## **APPLICANT'S COMMENTS ON SUBMISSION RECEIVED AT DEADLINE 6 FROM NATURAL RESOURCES WALES [REP6-049]**

### **HyNet Carbon Dioxide Pipeline**

Document Reference Number D.7:57

Applicant: Liverpool Bay CCS Limited

**Figure 1: Additional boreholes at the Alltami Brook crossing location**

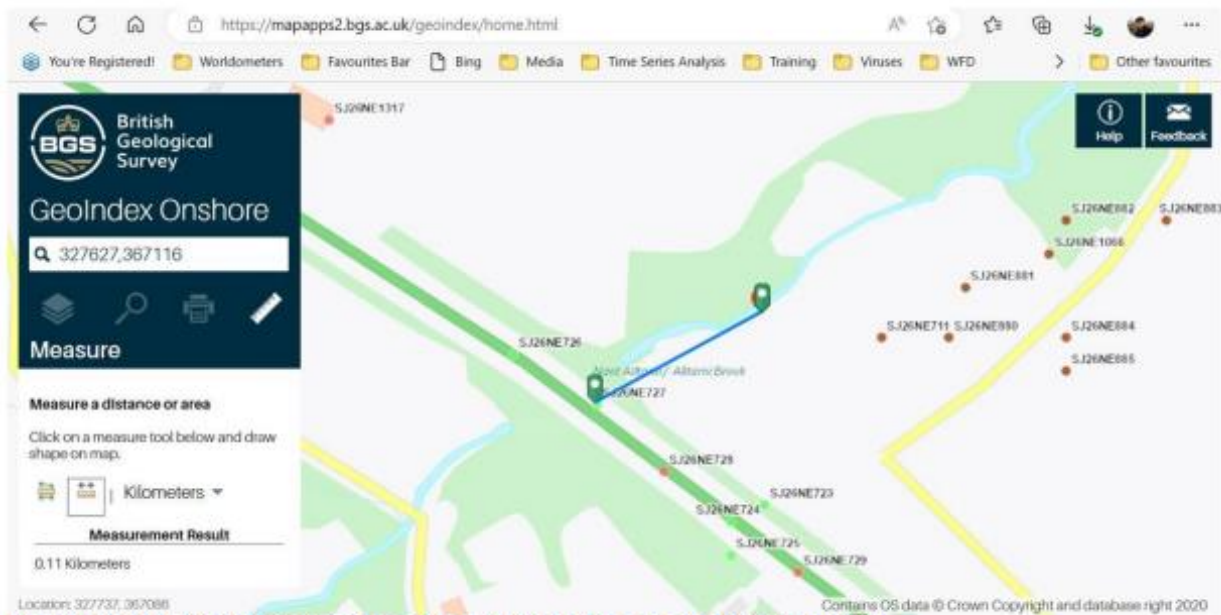
***Table 2.2 of the HIA presents information from four boreholes located along the A55 in proximity to the proposed Alltami Brook crossing point. NRW's review of the British Geological Survey's (BGS) GeoIndex shows the presence of other boreholes in the vicinity and their respective borehole logs which have not been considered in the HIA. These boreholes are shown on Figure 1 below, which also includes the approximate distance from the A55 to the proposed Alltami Brook crossing point. The information from the full complement of boreholes reveals that groundwater may not be present, and where it is found to be present the depths to which it is encountered vary. The information from the boreholes presented in the HIA is therefore not considered to be comparable or to provide a sense of continuity in the hydrogeological regime in the locale of the Alltami Brook crossing point. In addition, the boreholes presented in the HIA are installed within different geological units in comparison to the geological units within which the proposed pipeline would be installed, i.e., an 'isolated younger outcrop of Pennine Lower Coal Measures mudstone, siltstone and sandstone surrounded by the older Gwespvr sandstone (see Figure 3 below).***

2.2.8. With regard to Annex A, paragraphs 1.5-1.7 Submission Received at Deadline 6 from NRW **[REP6-049]**, NRW has provided an interpretation of the available borehole records, published by the British Geological Survey (BGS), which is the same dataset used by the Applicant. The Applicant acknowledges the availability of additional borehole records, and considered these when preparing the HIA. The Applicant presents further summary of the groundwater levels recorded at these boreholes.

2.2.9. The boreholes that indicate a very shallow or slightly artesian pressure upon completion are (note that these boreholes are all approximately 12-15m deep):

- SJ26NE726 (no completion water level but recorded at ground level at 1 metre before reached completion depth)
- SJ26NE727 (+ 0.3mAOD on completion)
- SJ26NE723 (at ground level on completion)
- SJ26NE724 (at ground level on completion)
- SJ26NE725 (at ground level on completion)

2.2.10. The borehole which was indicated that it was dry upon completion is (~40m deep):

- SJ26NE729

2.2.11. ] In paragraph 1.7 of the Submission Received at Deadline 6 from NRW **[REP6-049]** reference is made to borehole SJ26NE729, which the driller's log reports was dry upon completion. It should be noted that this is a single reading from one borehole which reports dry conditions, therefore, there is some question over the

validity of this. Another borehole, SJ26NE728 (of a similar depth to SJ26NE729), did not record a reading.

- 2.2.12. The Applicant understands that the boreholes along the A55 are in a different geology, and so may not be entirely representative of conditions at the preferred crossing location. However, they are installed within the same WFD groundwater body and have the potential to be in hydraulic continuity with the aquifer at the preferred crossing location, however also acknowledging that flow conditions in this area are laterally discontinuous, meaning that there is relatively little horizontal flow over longer distances.

- 2.2.13. The interpretation of the borehole records by NRW does not support its wider contention that there is potential for a significant loss of flow from the watercourse because there needs to be a direct flow pathway from the river into ground allowing a large, continuous flow of water out of the river system. Therefore, NRW's argument that flow conditions are not continuous does not lend itself to this being a realistic mechanism for significant flow loss.

**Figure 3: the relationship of the proposed Alltami Brook crossing point to the seepage reported in the HIA (para 2.7.9).**

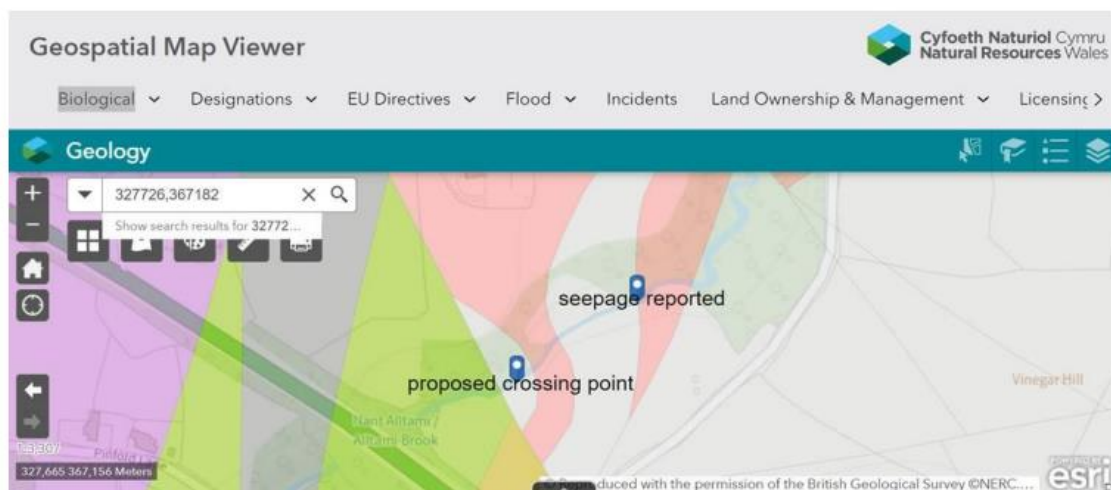
***The following excerpt (Figure 3 below) is from the NRW Geospatial Map viewer and shows the relationship of the proposed Alltami Brook crossing point to the seepage reported in the HIA (para. 2.7.9); it has been drafted using coordinates presented by the Applicant. Based on the mapping shown in Figure 3 below the seepage appears to be a contact seepage between the two different coloured units (designated as pink and grey in Figure 3) so may not be a fracture flow contribution, as hypothesised by the Applicant, but rather a manifestation of the permeability difference between where sandstone and mudstone contact each other, for example. This seepage point is approximately 120m downstream from the proposed crossing point and is at a lower elevation. The estimated crossing point elevation is ~73m AOD.***

***The seepage is therefore not considered reconcilable to the crossing point itself because the fault that is immediately upgradient of the crossing point may hinder groundwater flow in the bedrock. It is unlikely that there is consistent contribution of bedrock groundwater flow along the reach of Alltami Brook because such contribution would require a consistent network of saturated and transmissive fractures to intersect Alltami Brook. Figure 3.1 of the HIA (Preliminary Hydrogeological Conceptual Model) would suggest that such a consistent and spatially extensive network of saturated and transmissive fractures exists, which is unlikely to be the case as the borehole logs suggest, coupled with the possibility that local faulting hinders the continuity of groundwater flow.***

- 2.2.18. The Applicant notes that the location of the preferred crossing point on Figure 3 in Submission Received at Deadline 6 from NRW [REP6-049] is incorrect; the [correct] grid reference SJ 27650 67144 places it in the centre of the area of Gwespyr Sandstone (not on the Coal Measures as shown on Figure 3).
- 2.2.19. According to the Ordnance Survey (OS) mapping, the elevation at the preferred crossing point (SJ 27650 67144) is approximately 76mAOD. According to the OS, the elevation at the boundary between the Gwespyr Sandstone and the Pennine Lower Coal Measures is approximately 73mAOD.

- 2.2.20. Paragraph 2.79 of the HIA states: “During the site walkover, groundwater seepage issuing from the bedrock was observed at NGR SJ 27726 67182 (see photos in Annex A). This is located at the boundary of the Lower Coal Measures Formation (mudstone) and the Gwespyr Sandstone according to the geological map. This observation suggests that the Gwespyr Sandstone in the area is likely to be saturated and may contribute baseflow to the Alltami Brook.”

- 2.2.21. Therefore, this interpretation by the Applicant is in agreement with the statement made by NRW (Annex A, paragraph 1.8 of Submission Received at Deadline 6 from NRW [REP6-049]), i.e., that the seepage is coming from the boundary between the two rock types. This supports the Applicant’s position, as it indicates that groundwater is near or at ground level and there is an upwards hydraulic gradient from the bedrock which provides a contribution of baseflow to the watercourse.

**Figure 2: Compound 31A**

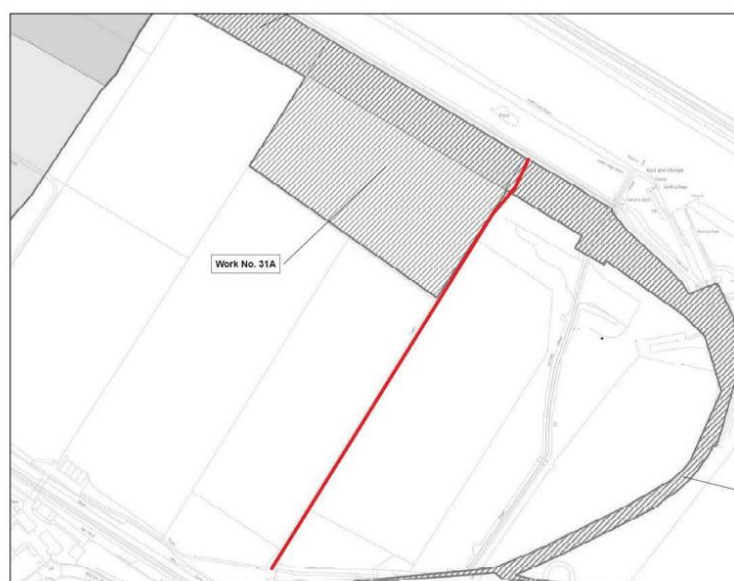
***The red line above shows NRW's only access point to the Hawarden Embankment at this location. It needs to be ensured that there are adequate access provisions for an excavator with flail to get on to the crest of the embankment. There are also key flood risk structures here (Beeches Drain outfall) that can only be accessed at this point. It needs to be ensured that the compound layout does not prohibit access and any fencing is adequately offset from the access track so that this remains free from any obstructions.***

***The access route to the south of the River Dee was unidentified as the Applicant had understood access was taken over the track further to the east. It is helpful that this has been clarified. The Applicant is happy to commit to maintaining the current access (adjacent to compound 31A and perpendicularly over the Applicant's access route) open for use by NRW, including access across the route of the Applicant's access. Again, there may need to be some minor works in plot 14-14a (such as pothole repair) but they would be designed so that the access was not blocked.***

2.3.2. The Applicant has proposed alternative wording securing the above to NRW and awaits their comments.
